SUBJECT: Response to Request for Additional Information Regarding
Extended Power Uprate
Grand Gulf Nuclear Station, Unit 1
Docket No. 50-416
License No. NPF-29

Response to Request for Additional Information

Mechanical and Civil Engineering Branch, Steam Dryer (Non-Proprietary)

Figure 3: QC2 Replacement Dryer, Strain Gauge S9.

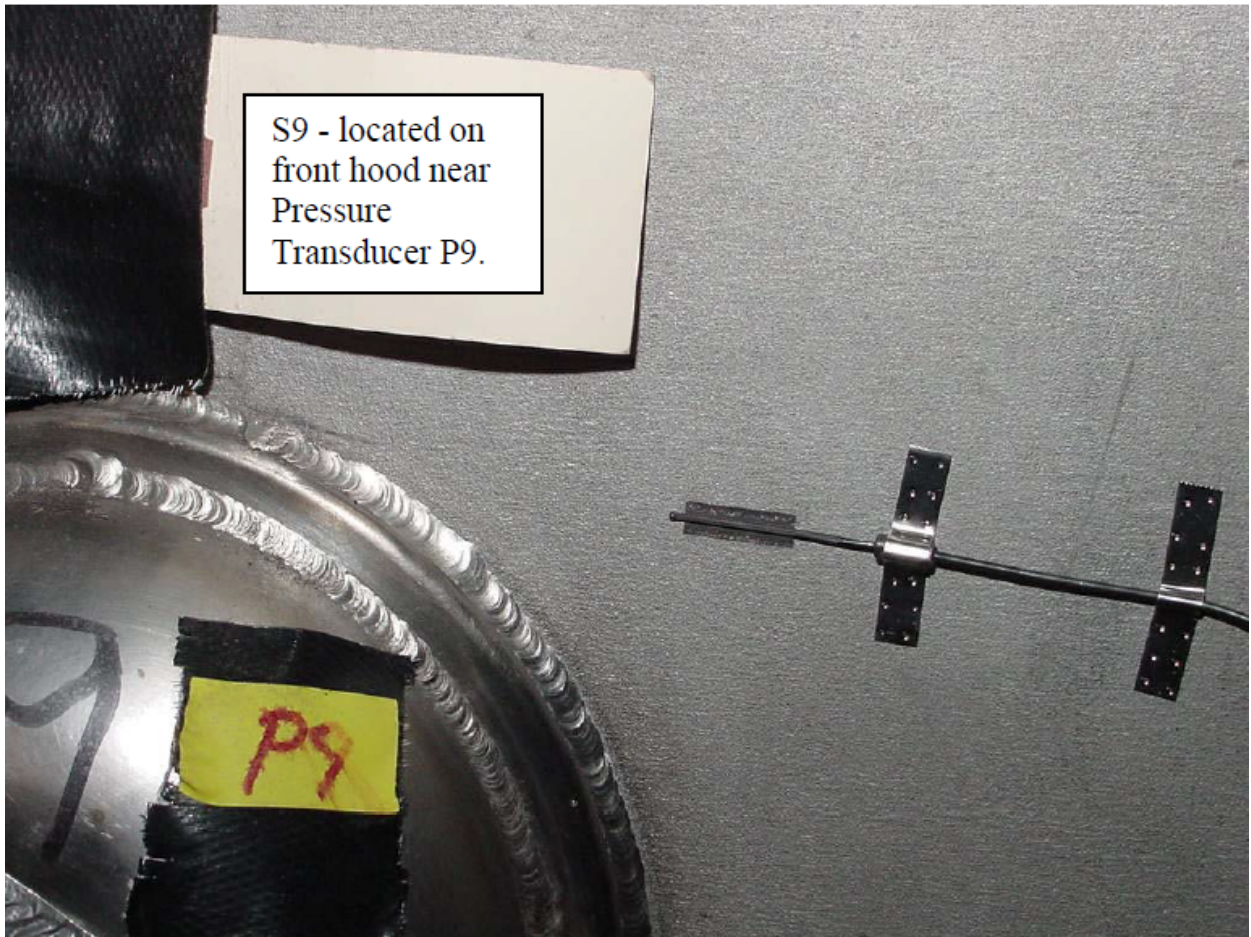
The licensee is requested to provide a detailed description of the bias errors and uncertainties (including actual values) of the strain gages used for the QC2, SSES, and GGNS MSL acoustic pressure measurements and how they are accounted for in the PBLE benchmarking and in the GGNS dryer analysis. In particular, the licensee is requested to explain the ramifications [[

]] Finally,
the licensee is requested to address how these errors affect the PBLE benchmarking and the GGNS dryer stress calculations.

GGNS has elected to pursue on-dryer instrumentation for the GGNS replacement dryer. Specific details of the data acquisition system (DAS) are still being finalized. The planned strain gages are Kyowa Model KHC-10-120-G9, the model used on the QC2 and SSES1 replacement dryers, or an equivalent model.

The installation and data acquisition procedures for the GGNS on-dryer instrumentation will follow the procedures used at QC2 and SSES1 and incorporate operating experience from those measurement sessions. [[

The installation procedure, data acquisition procedure, instrumentation acceptance criteria, and instrumentation startup report from the previous work will be updated for GGNS. Examples of these documents from QC2 and SSES are References 4, 5, 6 and 7. Figure 3 is strain gage S9 as installed on the QC2 replacement steam dryer.
